April 2017
FL724A-Q
NHTSA #16V-666 (Non-School Buses)
NHTSA #16V-664 (School Buses)
SECOND REVISED NOTICE

Subject: ICU3S Instrument Cluster Hydraulic Brake Telltale

Models Affected: Specific Freightliner Business Class M2 vehicles and Freightliner Custom Chassis S2 bus and B2 (Thomas Built Buses C2 Saf-T-Liner) school bus chassis manufactured March 3, 2015, through September 8, 2016.

Fig. 1, "Park" Telltale - Replace ICU3S

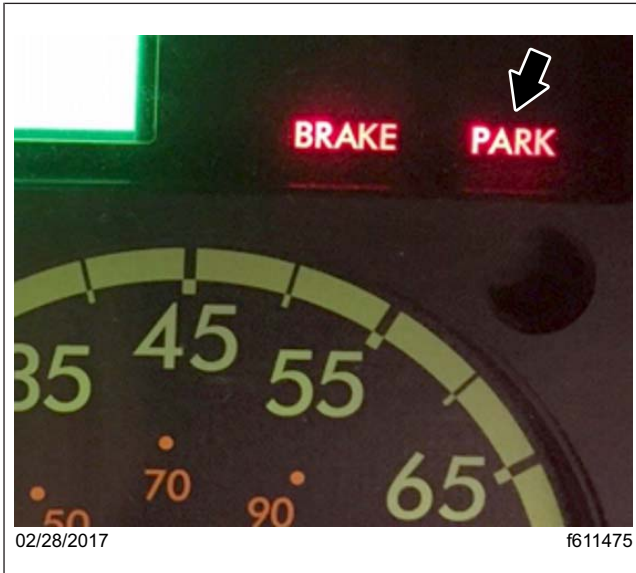
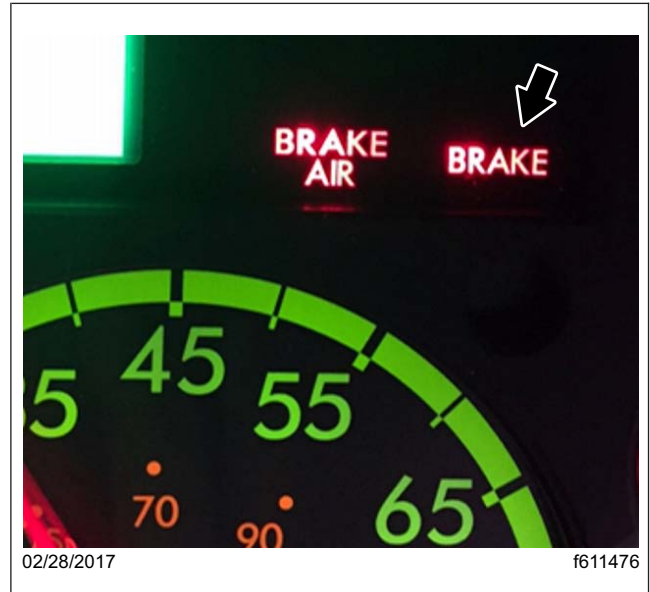
1. Check the base label (Form WAR259) for a completion sticker for FL724 (Form WAR260) indicating this work has been completed. The base label is usually located on the passenger-side door, about 12 inches (30 cm) below the door latch (trucks) or over the driver's window (buses). If a completion sticker is present, no work is needed. If a completion sticker is not present, proceed to the next step.
2. Park the vehicle, shut down the engine, and apply the parking brakes. Chock tires.
3. During the bulb check at key-on, inspect the telltales on the ICU3S (affected telltales will be illuminated for three seconds). See **Fig. 1** and **Fig. 2**

If the ICU3S has a "Park" telltale, continue with the next step.

If the ICU3S has a "Brake" telltale, no further work is needed. Clean a spot on the base label (Form WAR259), write the recall number, FL724, on a red completion sticker (Form WAR260), and attach it to the base label.
